December 1, 2018

Version 2

Safety Recall: B-Pillar Trim Clip Mounting Hole

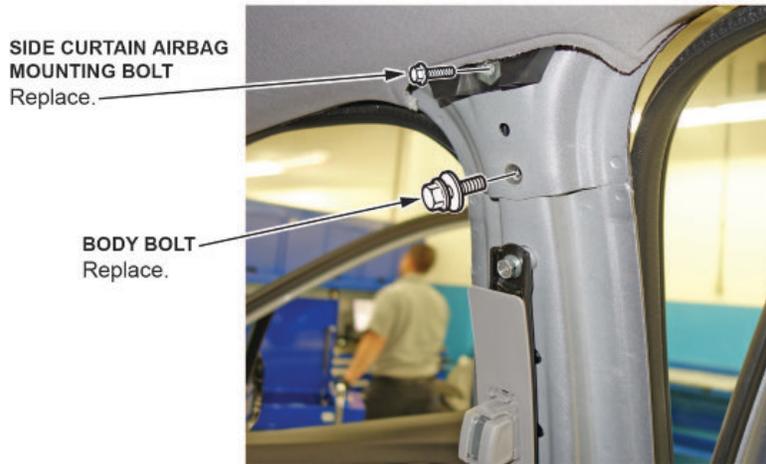
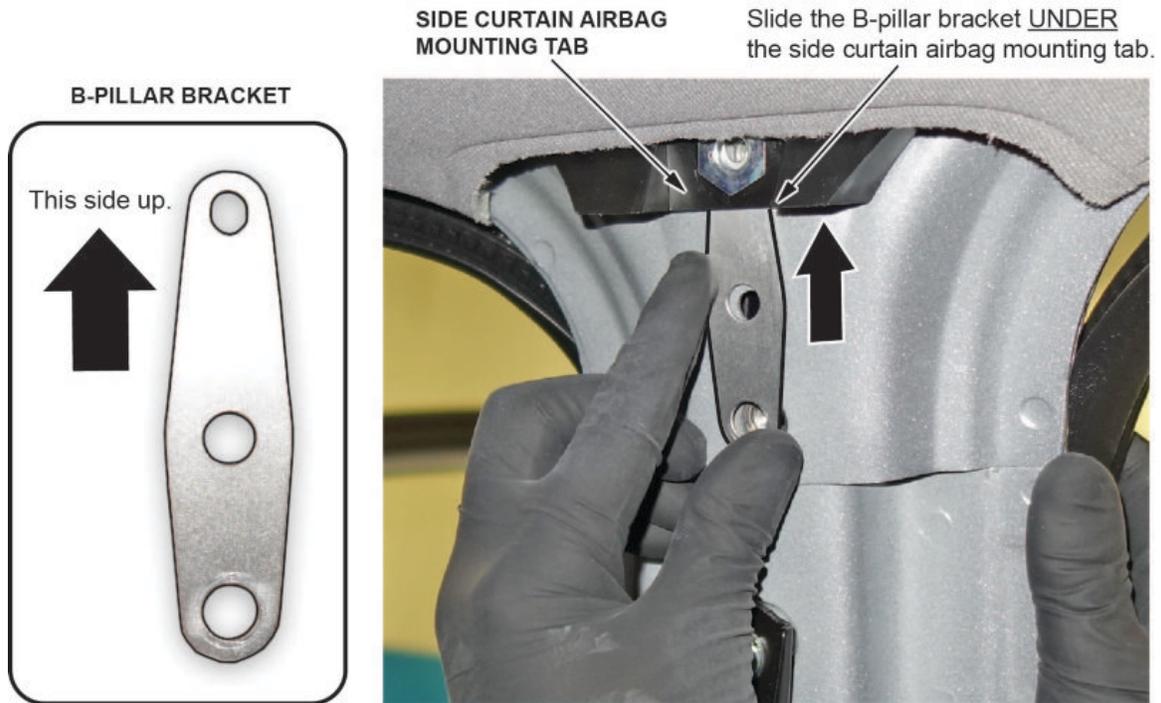
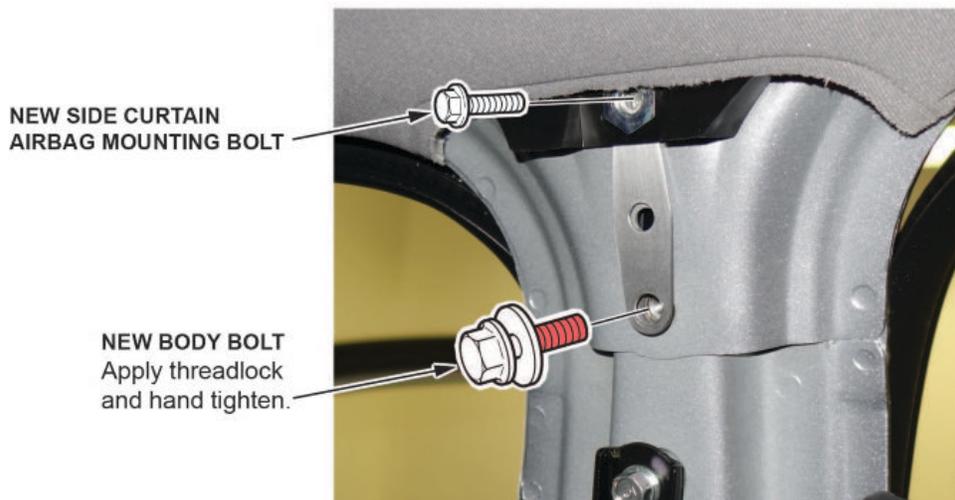
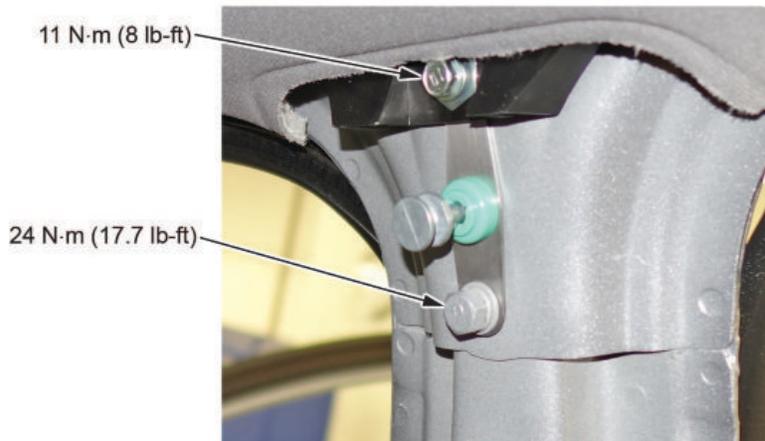
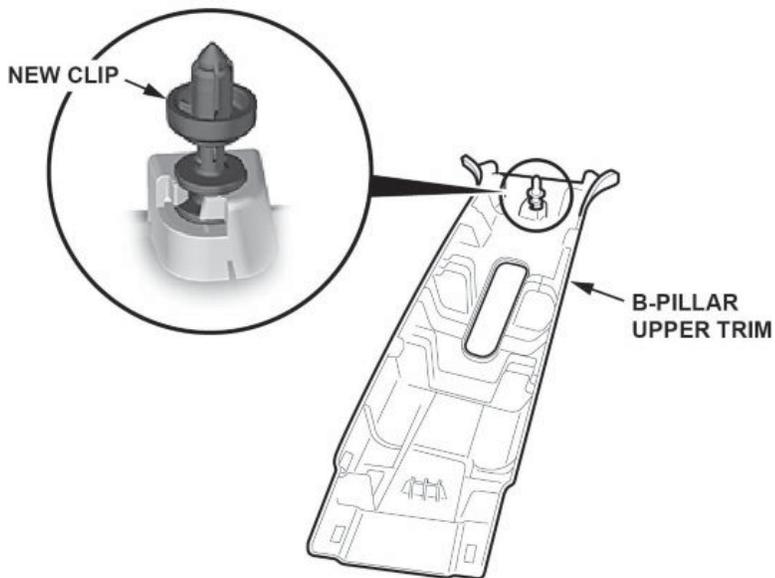
There was a manufacturing error in a limited number of vehicles where the B-pillar trim clip mounting hole on the passenger's side of the vehicle was made too large and does not hold the clip to its specified tension. If the vehicle is involved in a collision where the side curtain airbag is deployed, it may not deploy as designed and increase the risk of injury to occupants.

Install a B-pillar trim bracket on the passenger's side B-pillar.

9. Install the B-pillar bracket.

9.1. Remove the side curtain airbag mounting bolt.

9.2. Remove the body bolt as shown.

9.3. Position the B-pillar bracket under the side curtain airbag mounting tab.

9.4. Install the new side curtain airbag mounting bolt, finger tight.

9.5. Apply Hondaloc3 threadlock to the new body bolt, and install it finger tight.

9.6. Align the bracket hole with the original clip hole by inserting the new B-pillar upper trim mounting clip into the bracket hole.

9.7. With the clip in the hole, torque the two bolts to the following specifications:

- Side curtain air bag mounting bolt: **11 N·m (8 lb-ft)**.
- Body Bolt: **24 N·m (17.7 lb-ft)**

9.8. Remove the clip, and confirm the bracket hole is aligned with the original hole.
